King's Daughters

KD-3123.0-26

GC Services for UK King's Daughters Medical Center – Greenup Co. Urgent Care/Family Care Medical Office Building

ADDENDUM # 02

L-306
COPYRIGHT 2026 - JRA, INC.

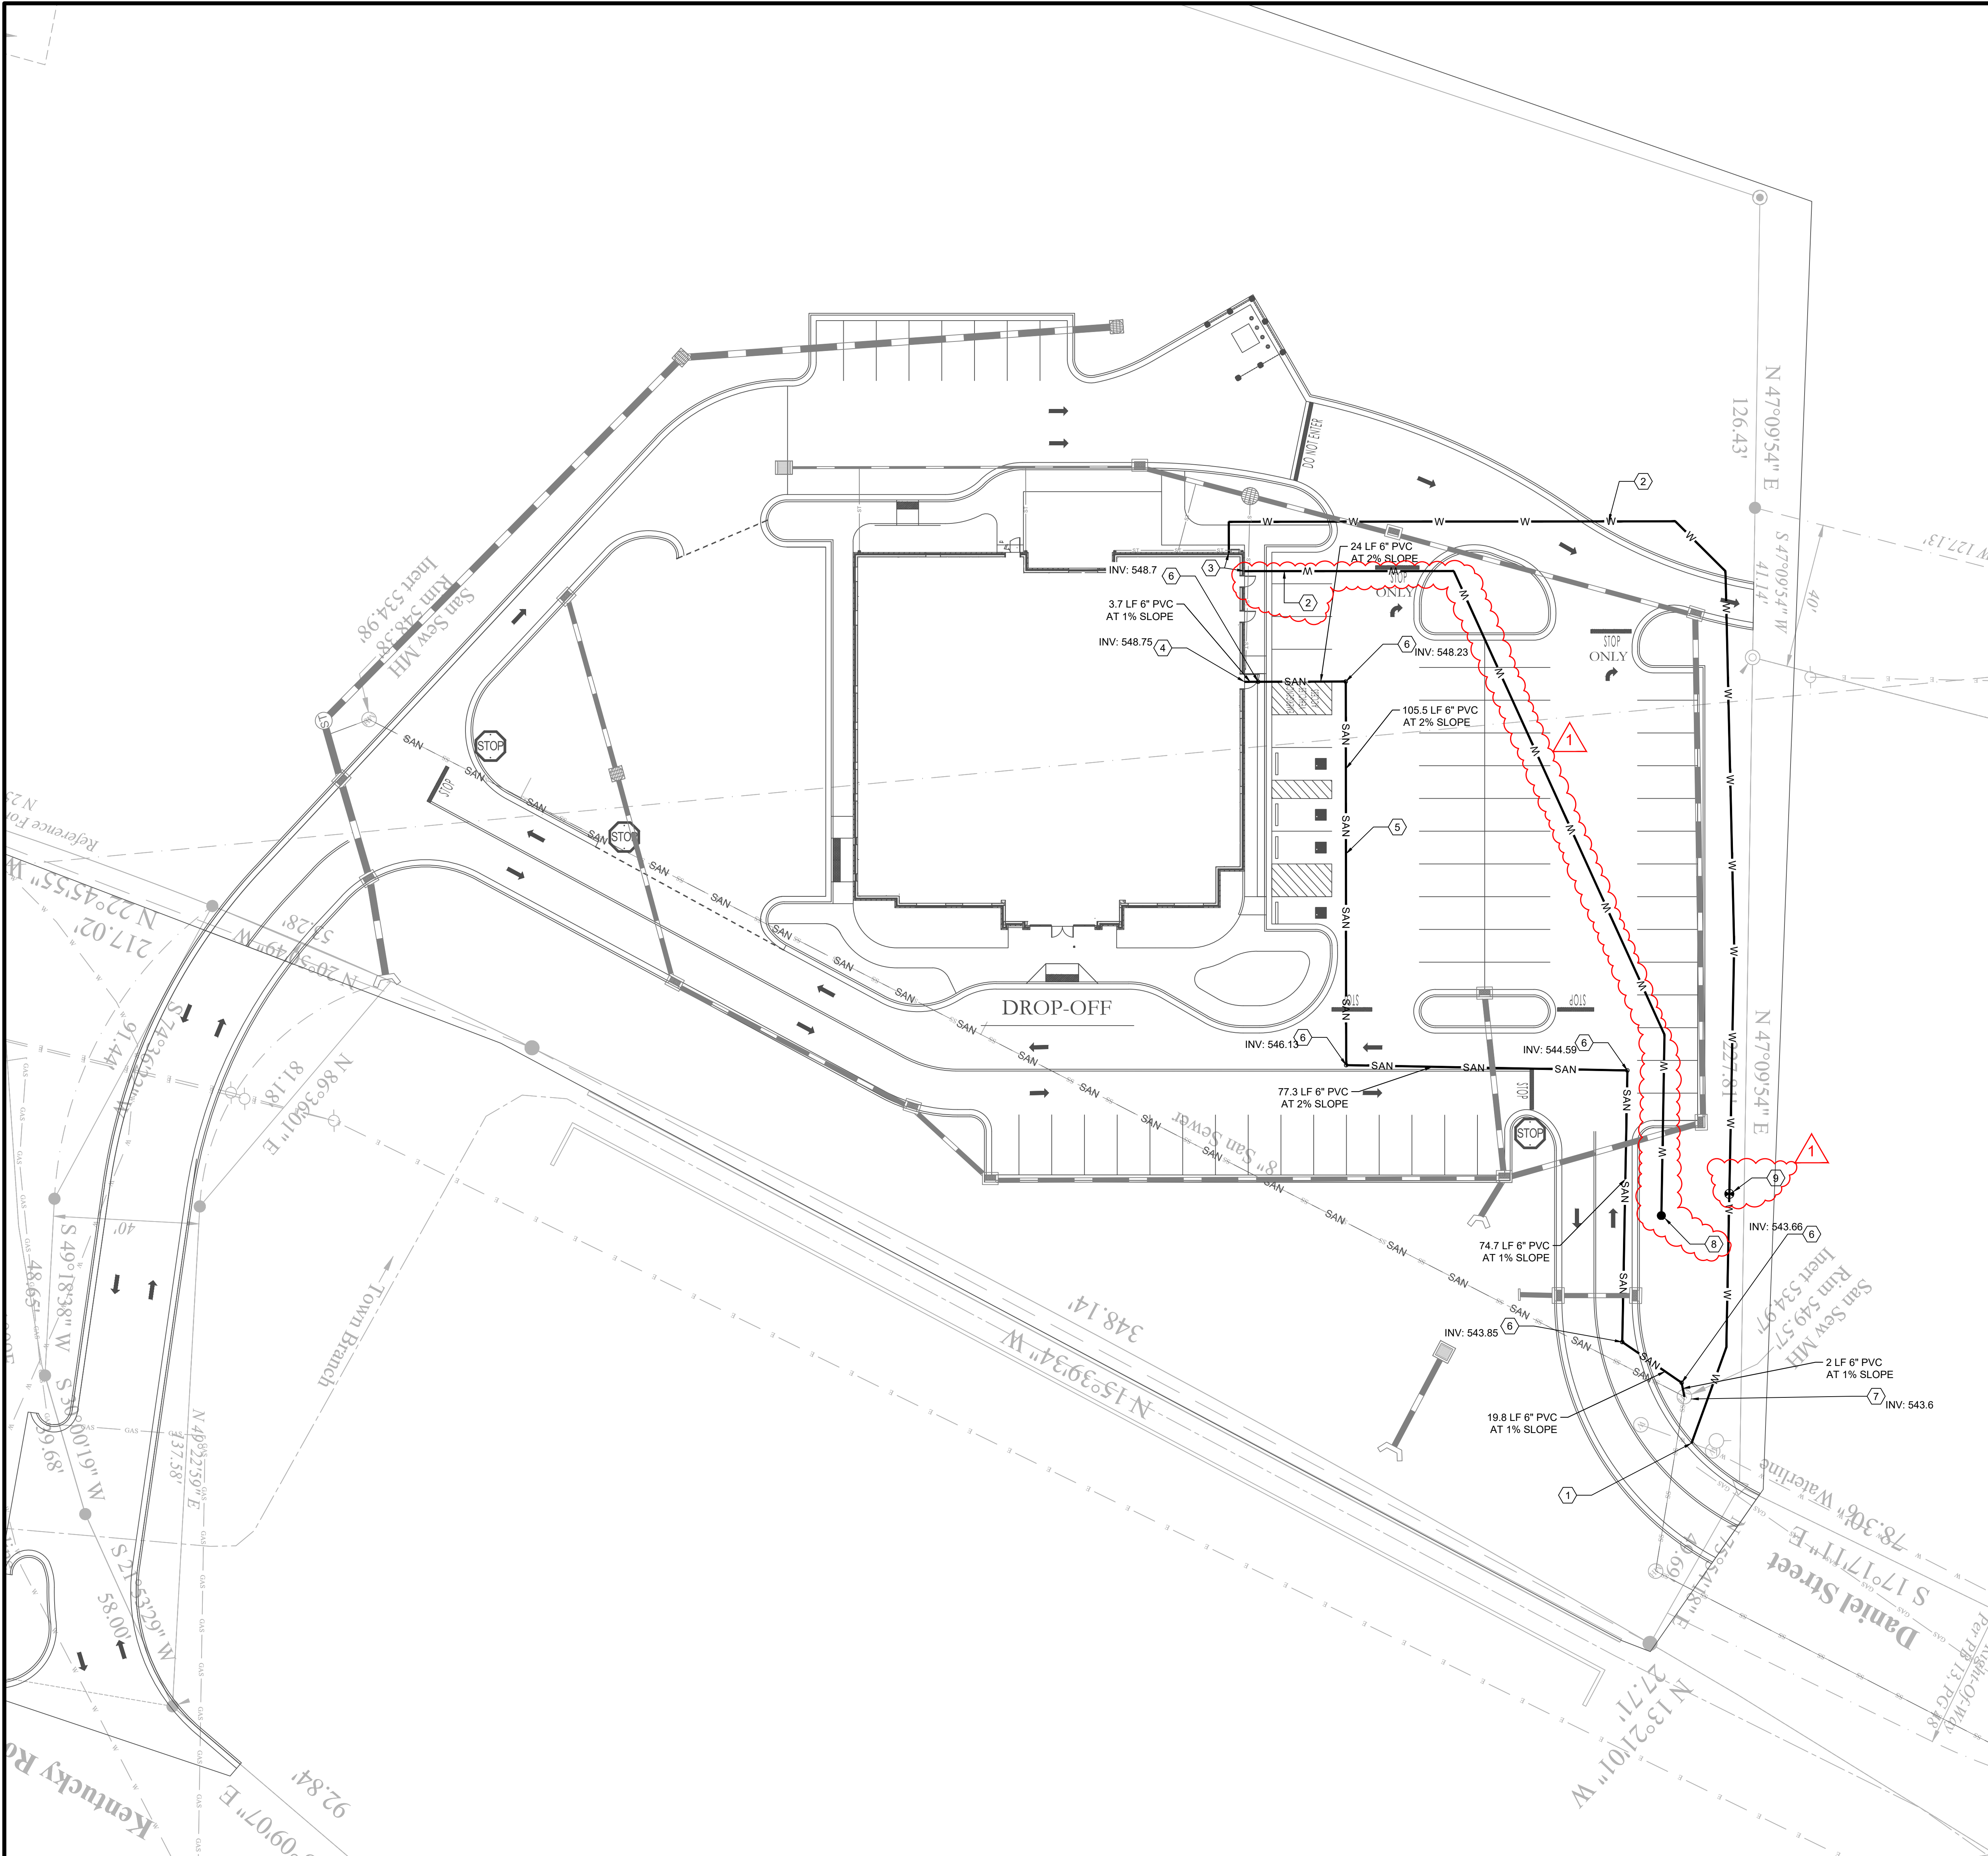
Refer to the attached revised Sheet L306 Detention Basin Plan, Sections and Details: Revised quantity of Perforated Pipe in Detention Basin

C-101
COPYRIGHT 2026 - JRA, INC.

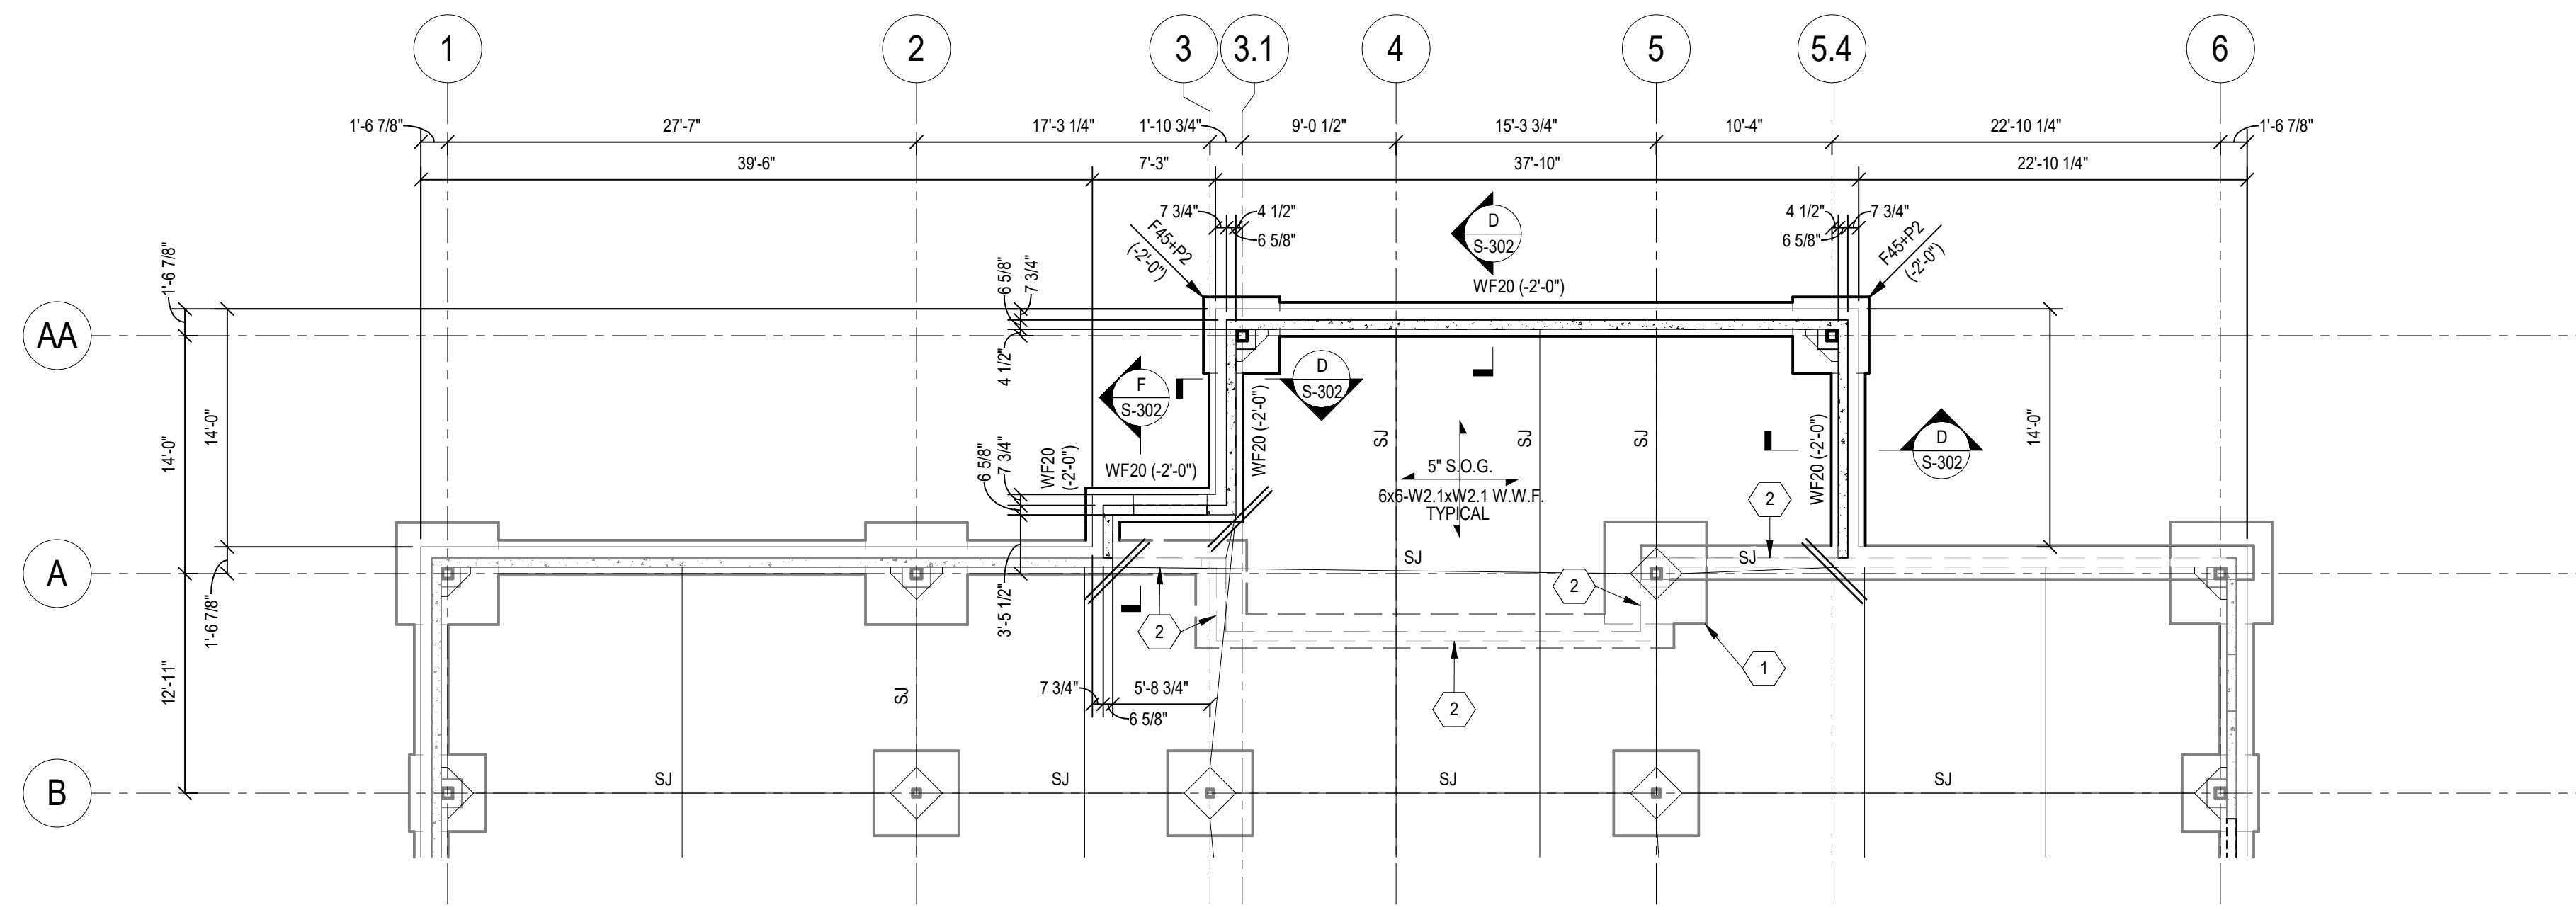
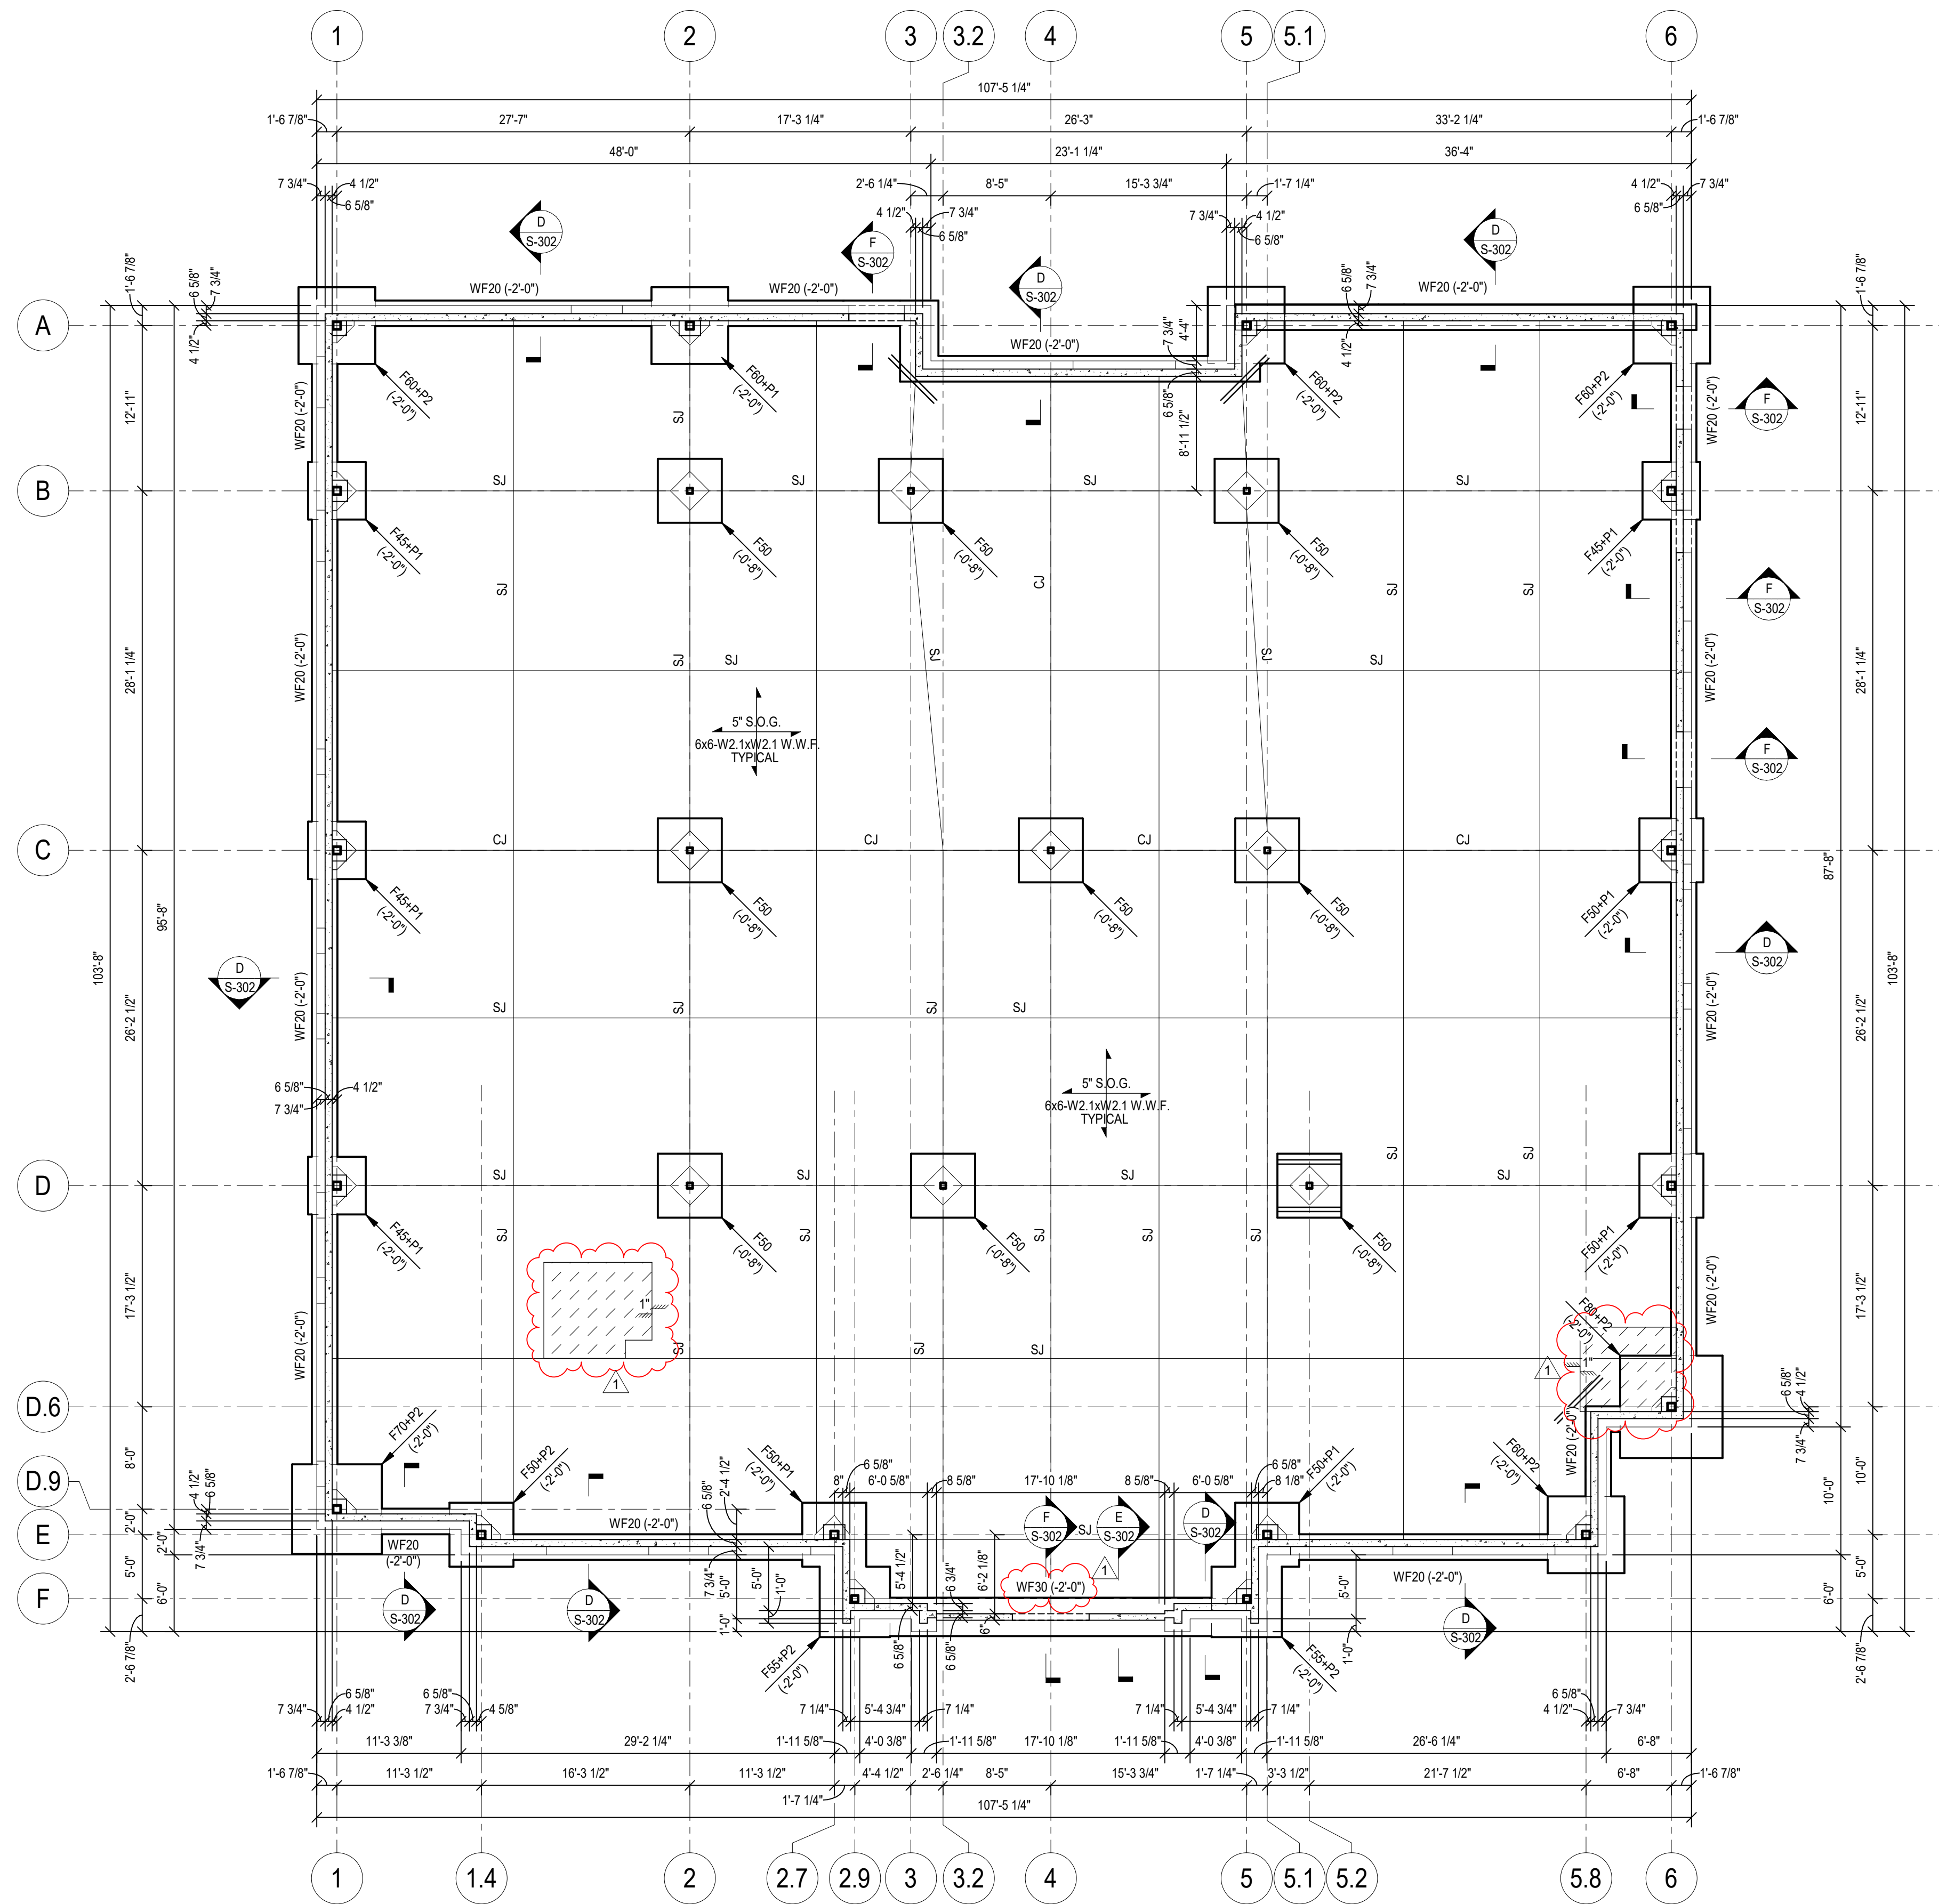
Refer to the attached revised Sheet C101 Site Utility Plan: FDC location has been adjusted.
